Construction Division
Additions & Alteration Charges Approval Form

GULMOHAR RESIDENCY

Details of Additions & Alterations

Flat No	304	Block no.	' D '
Flat Area	1660 sft	Type	Deluxe / Luxury
Buyer Name	Chaganti Mallikarjuna Bhanu		
Phone No.	9963090972	Email

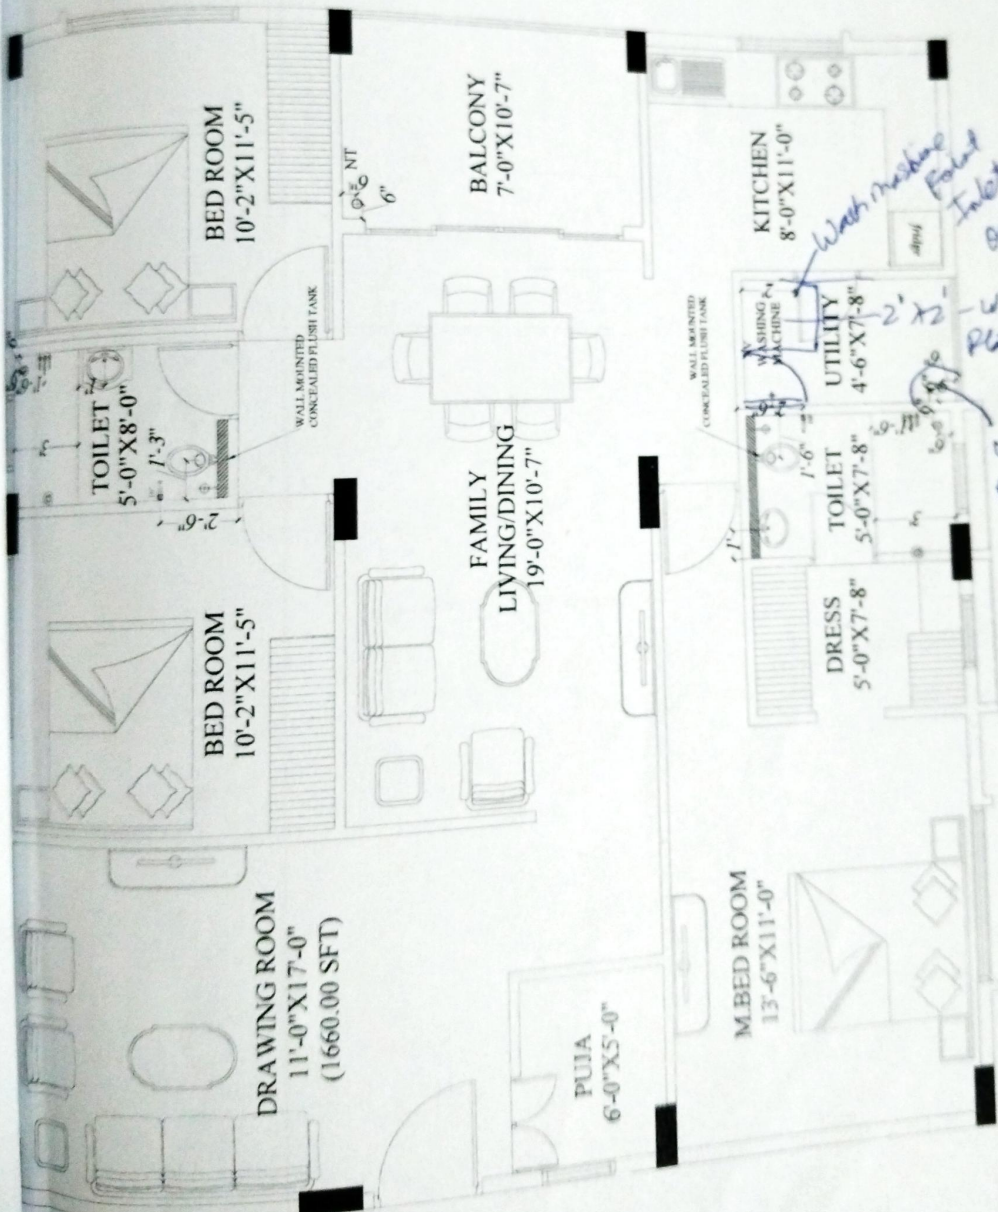
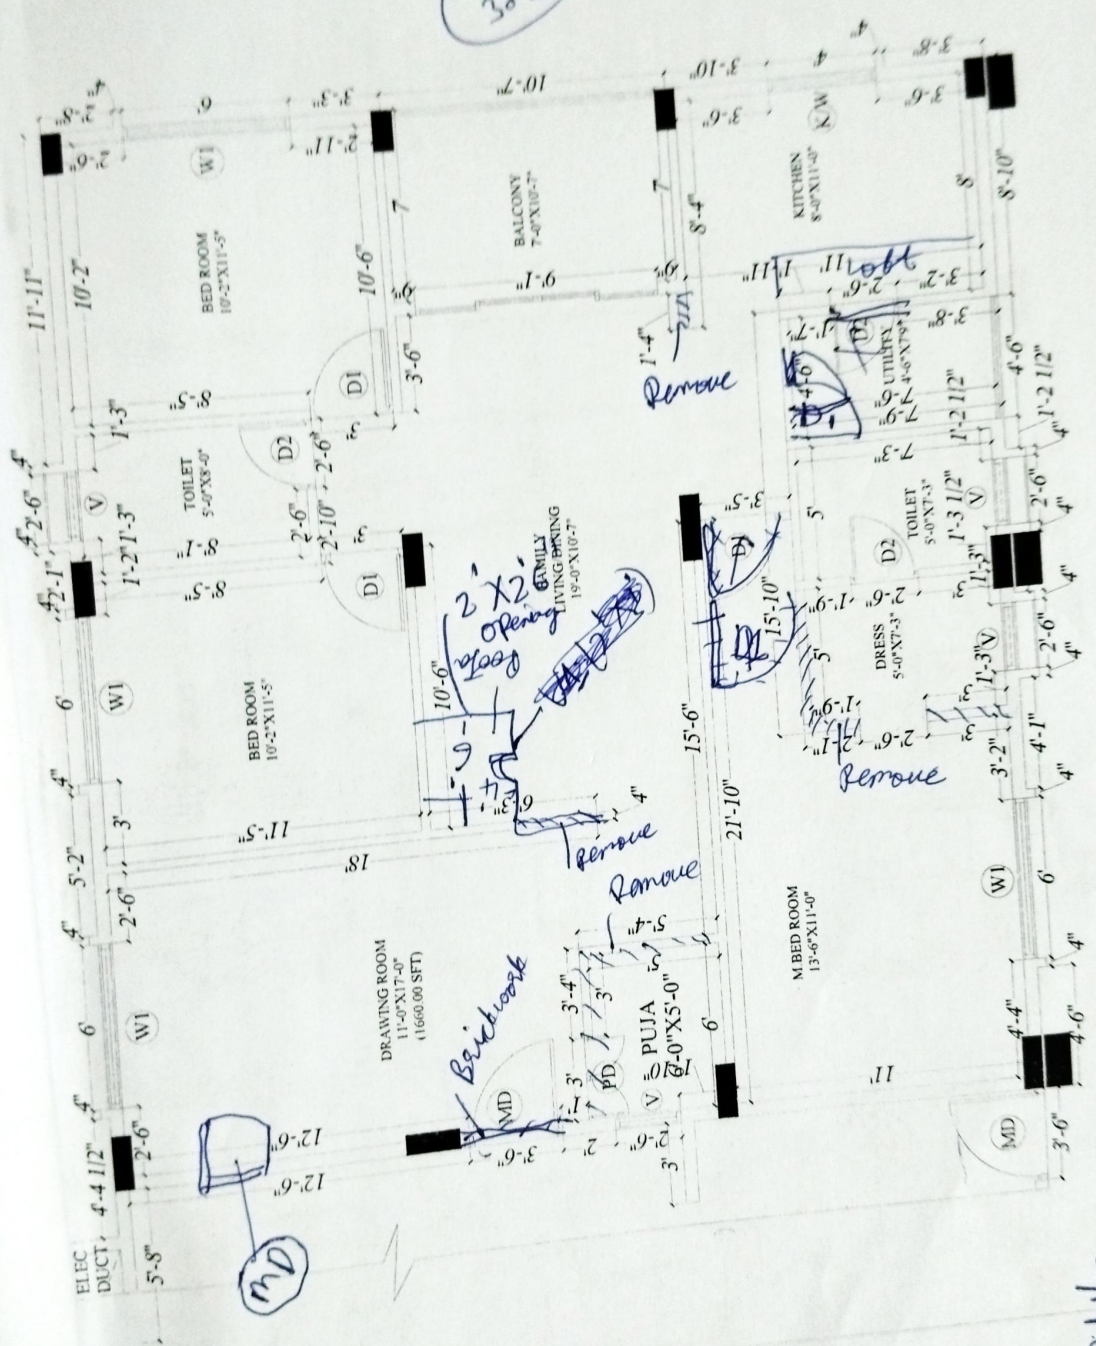
1) Anglo Indian getting buy customer EWC
Refund of our company in Bath Bathroom.

1) utility door & door frame Refund & going for granite
door Sobite & door getting by customer.
